PLANS AND DOCUMENTS
referred to in the PDA
DEVELOPMENT APPROVAL

Approval no: DEV2024/1580
Date: 17 June 2025

client	BLUE CHP LIMITED
project	AURA SOCIAL HOUSING BLUECHP
locale	75 ADRIAN CIRCUIT, NIRIMBA QLD, 4551
title	DEVELOPMENT SUMMARY

2 NORTH ELEVATION
SCALE 1 : 250

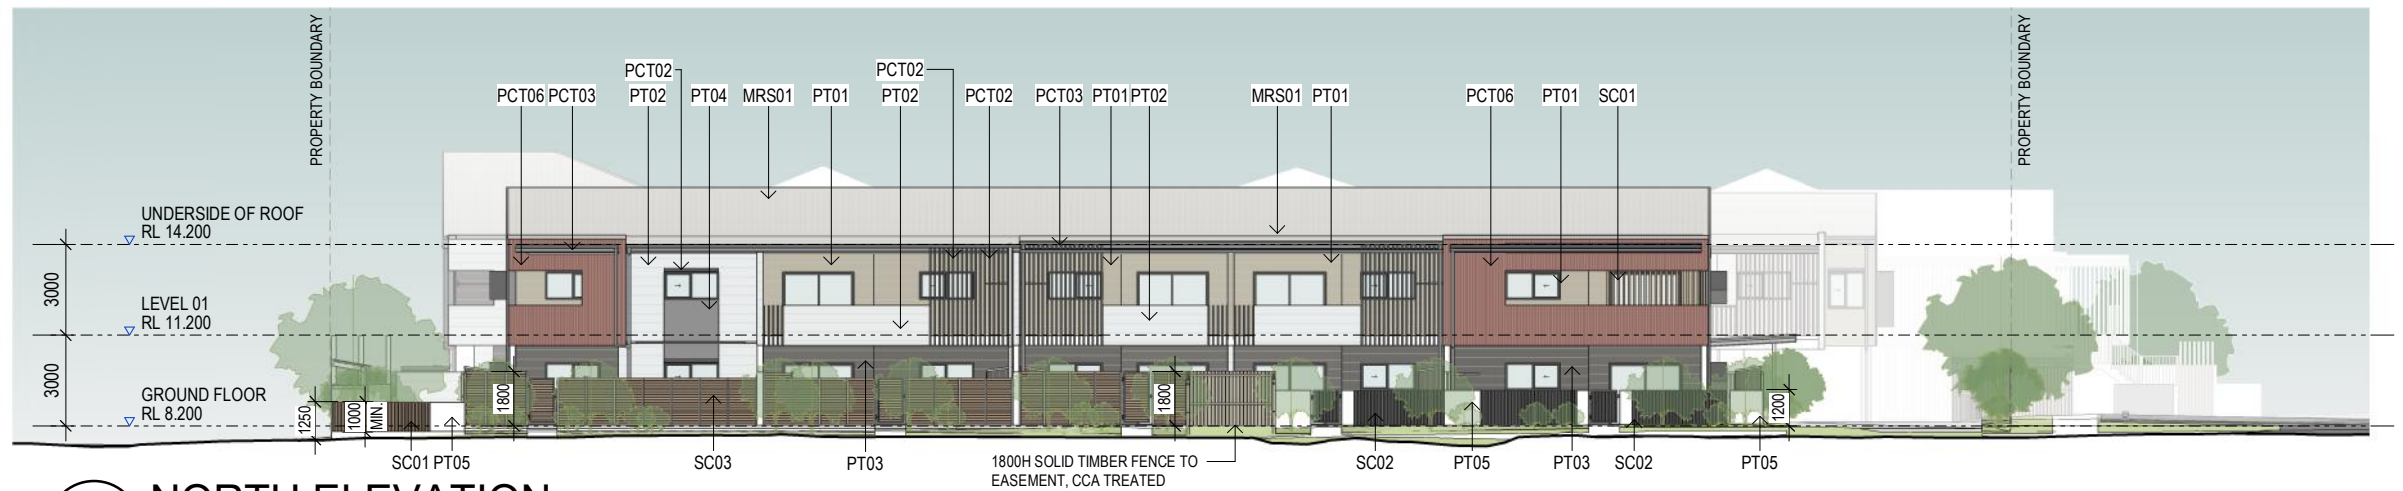
Front fencing along the eastern elevation must be at least 50% transparent where greater than 1.2 metres in height

2 WEST ELEVATION
SCALE 1 : 250

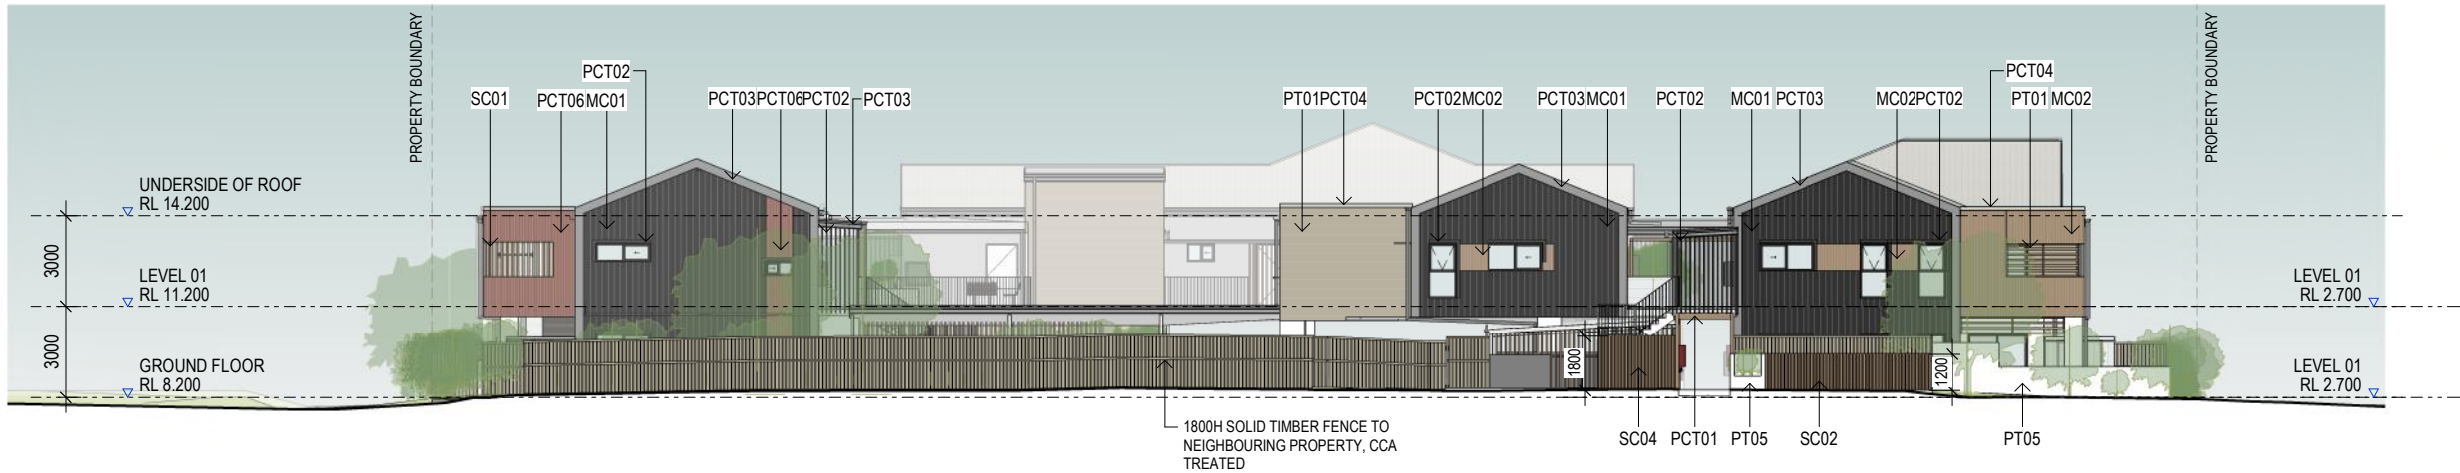
Front fencing along the southern elevation must be at least 50% transparent where greater than 1.2 metres in height
